**REVIEW NOTES**  
**BRATTLEBORO BRO 1442(35) – BRIDGE NO. 7**  
**TEMPORARY BRIDGE DRAWINGS**  
**May 22, 2014**

**RE:** Temporary Bridge Drawings received from Renaud Bros. Inc on 5/22/2014.

This submittal review is for sheets 1-33, inclusive, of the “Brattleboro(35)-TempBypassRev2” submittal received on 5/22/2014.

### Temporary Bridge Revision 2 Explanation

**From:** Burbank, Scott [<mailto:SBurbank@VHB.com>]  
**Sent:** Wednesday, March 05, 2014 5:36 PM  
**To:** Chenette, Michael  
**Cc:** [mike.chenette@stantec.com](mailto:mike.chenette@stantec.com); Sumner, Todd  
**Subject:** Brattleboro BRO 1442(35) - Ladder Truck Turning Movements

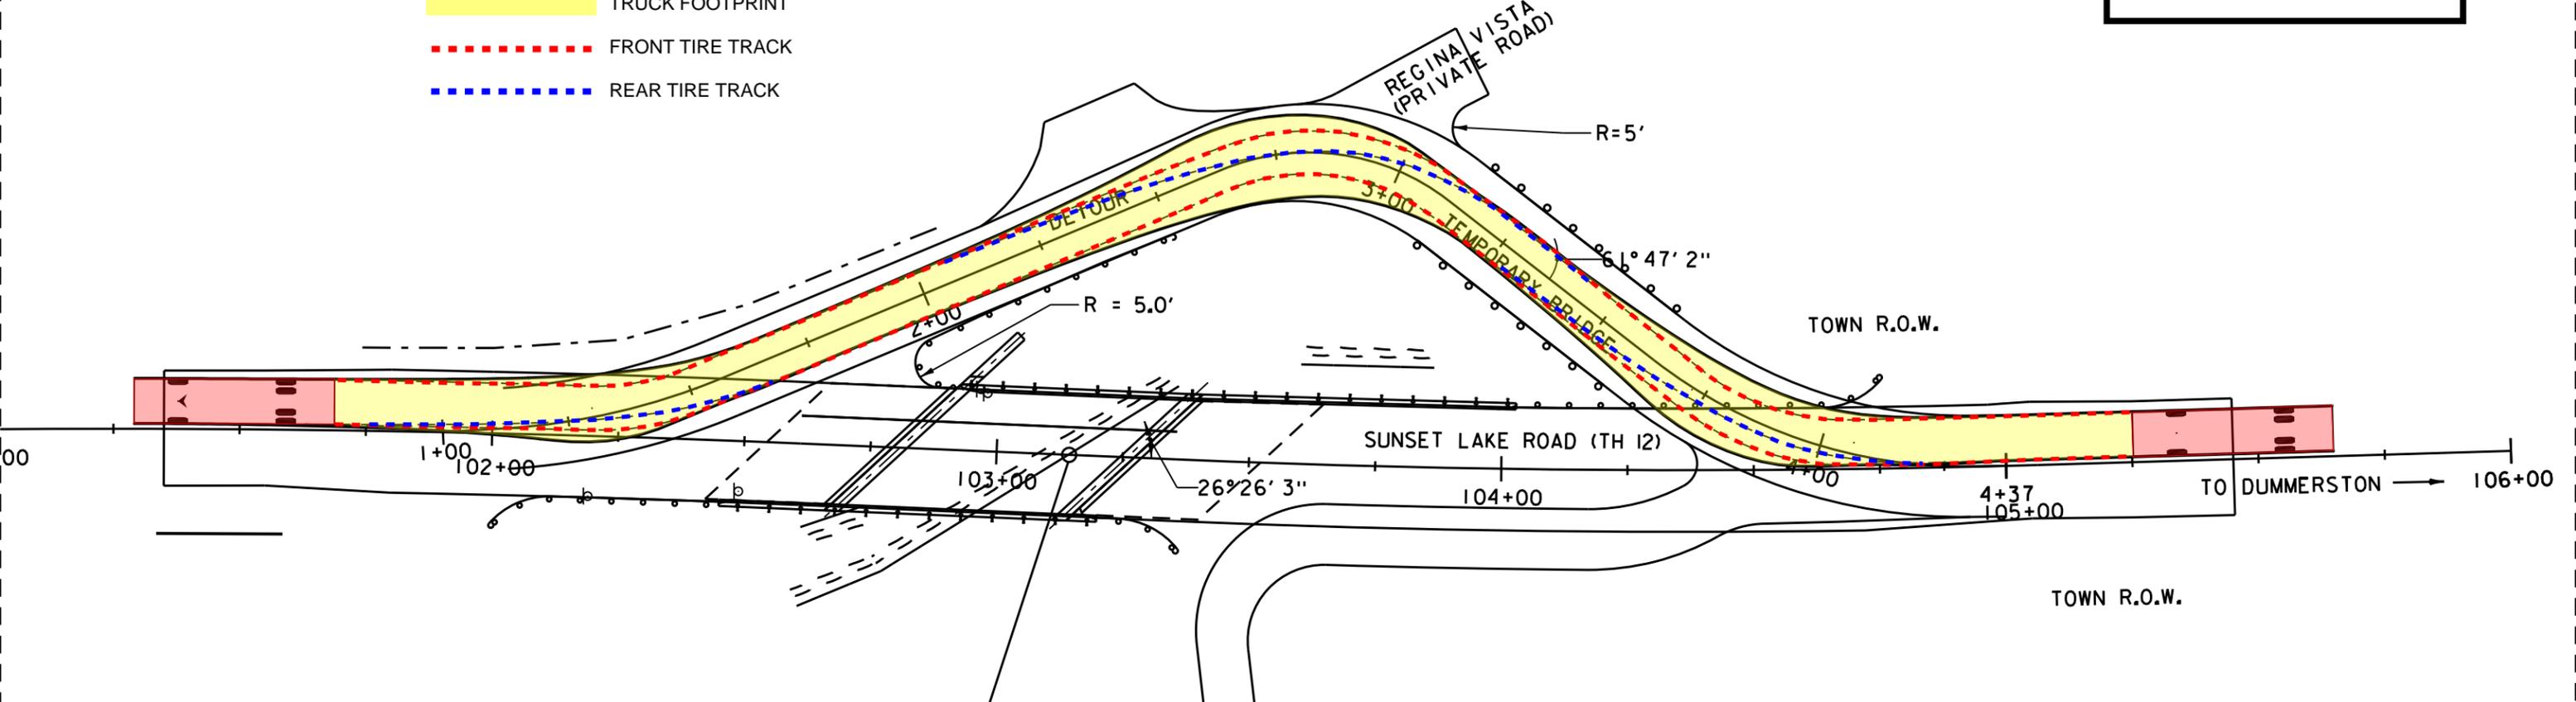
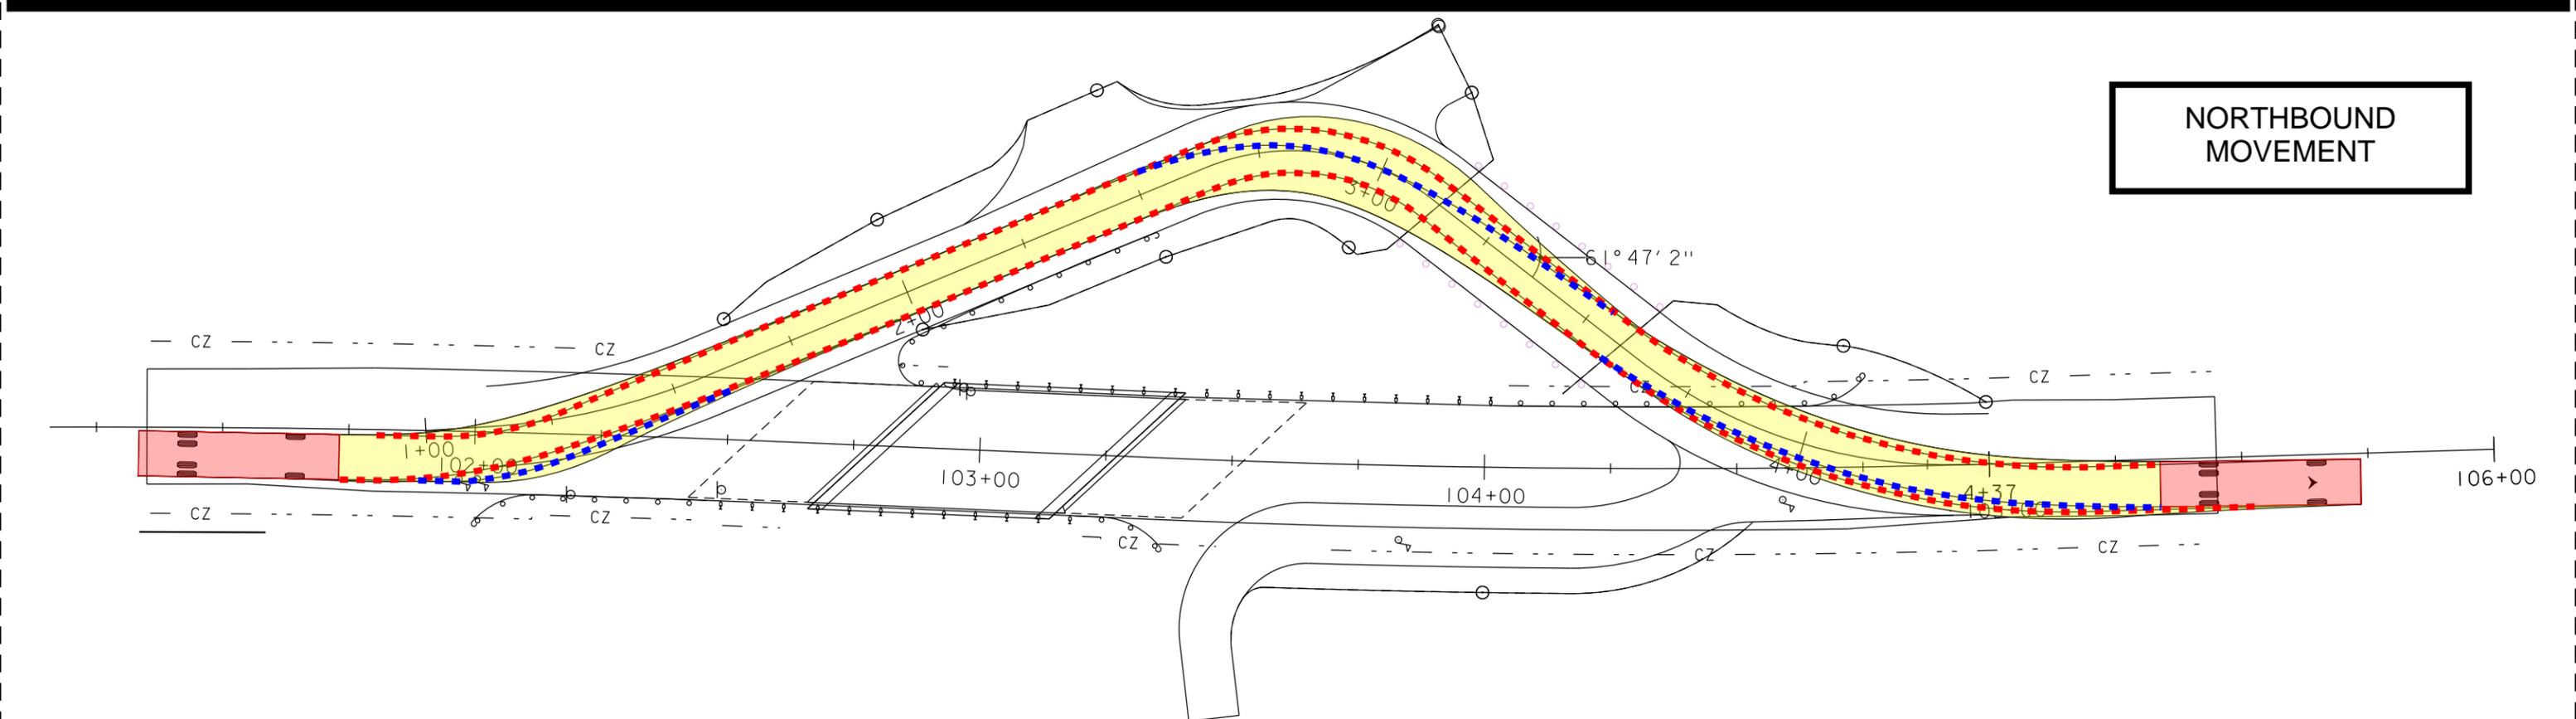
Based on the attached information provided by Michael Bucossi, Town of Brattleboro Fire Chief, we developed a model of the Brattleboro Ladder Truck in AutoTurn which we “drove” through the detour using the AutoTurn program. As noted in the attached PDF the Brattleboro Ladder Truck is capable of maneuvering through the detour.

The ladder truck turning movements have been reviewed and it looks like it should be capable of maneuvering through the detour, as designed.

REV.			JOB NAME: BRATTLEBORO
			JCB NO: BRC 1442(35)
NO.	DATE	COMMENTS	SHEET NAME: RAIL ATTACHMENT DETAIL
1	5/5/14	WIDEN APPROACH	
DATE:	1/31/14		
DRAWN BY:	A.D.		
CHK'D BY:	C.E.		
			SHEET: <b>6</b>

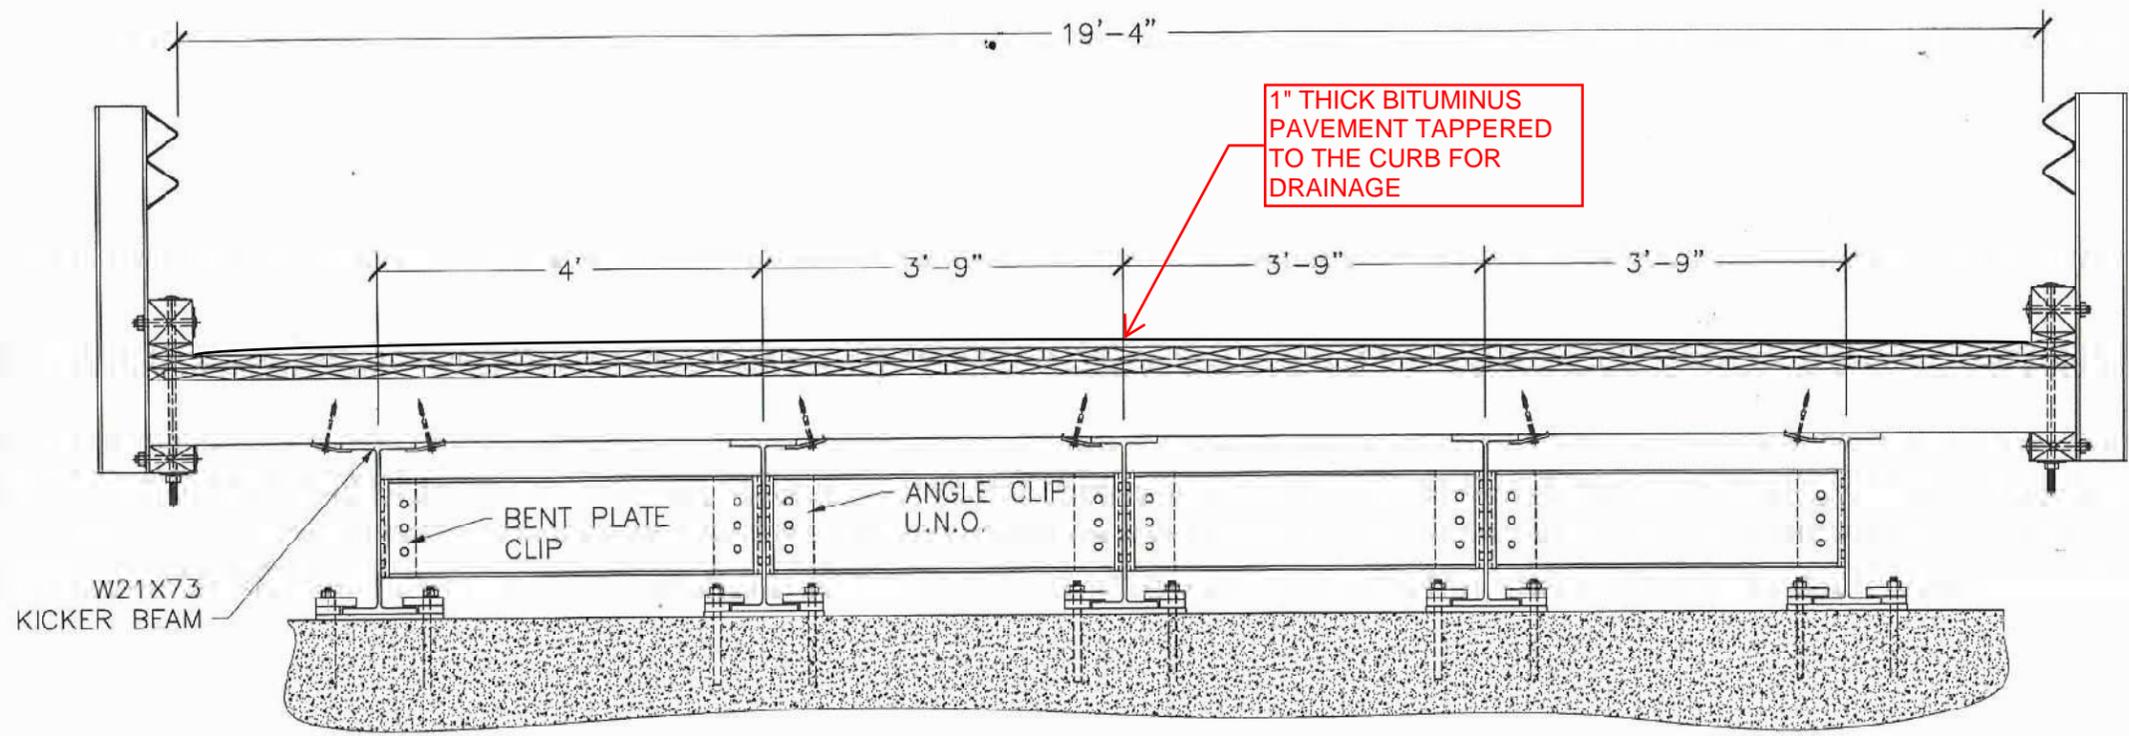
3. Additional information on how drainage will be provided for on the bridge.

Sheets 6 and 8 show how the bridge drains with an inch of pavement tapered to the curb where the 1 ½" spacer is staggered so water can run off the bridge deck.

**CRANE LAYOUT PLAN**

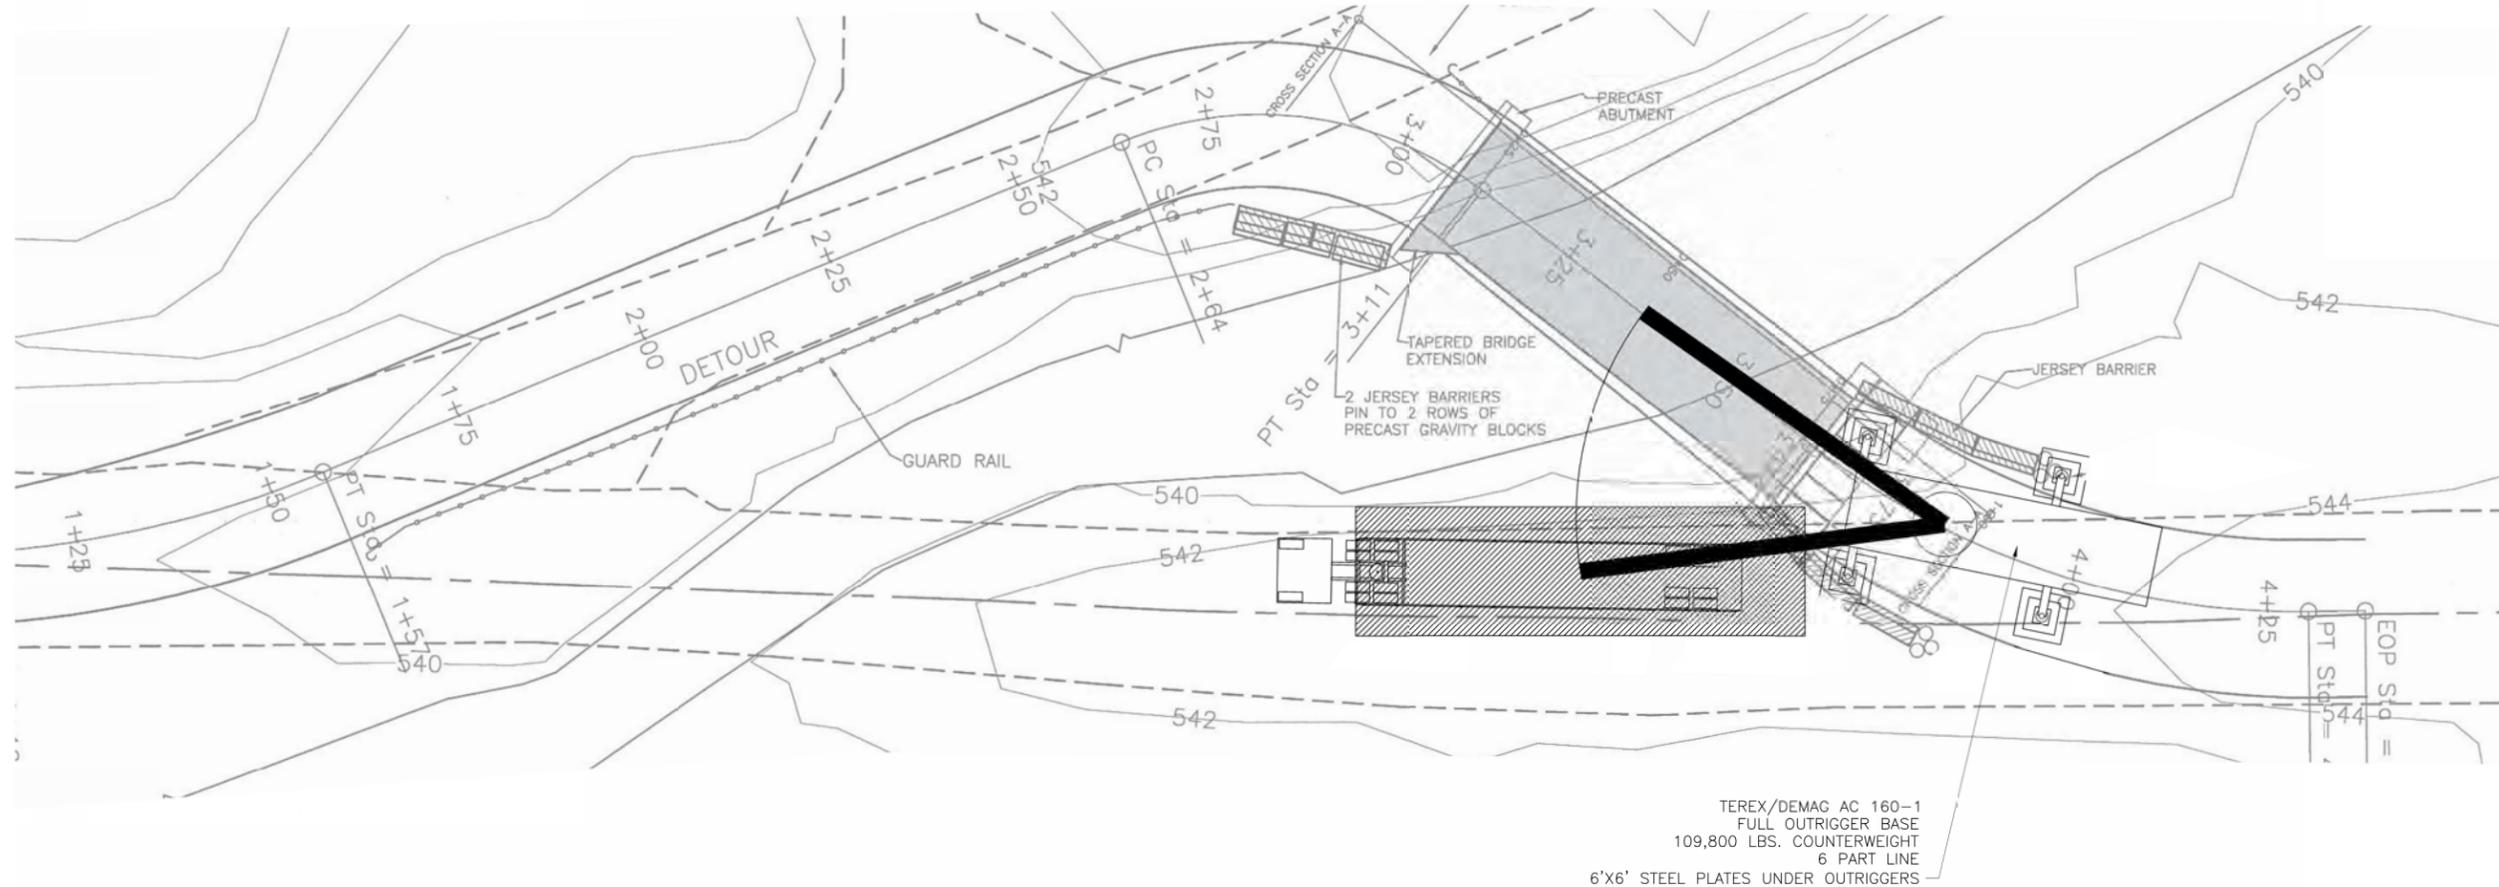
2. Additional information on the method of erection (not just the sequence) of the temporary bridge that satisfies Specification Section 528.04(b)(3).

An erection plan has been included showing the crane placement, lifting capacities, radius, and rigging capacities.
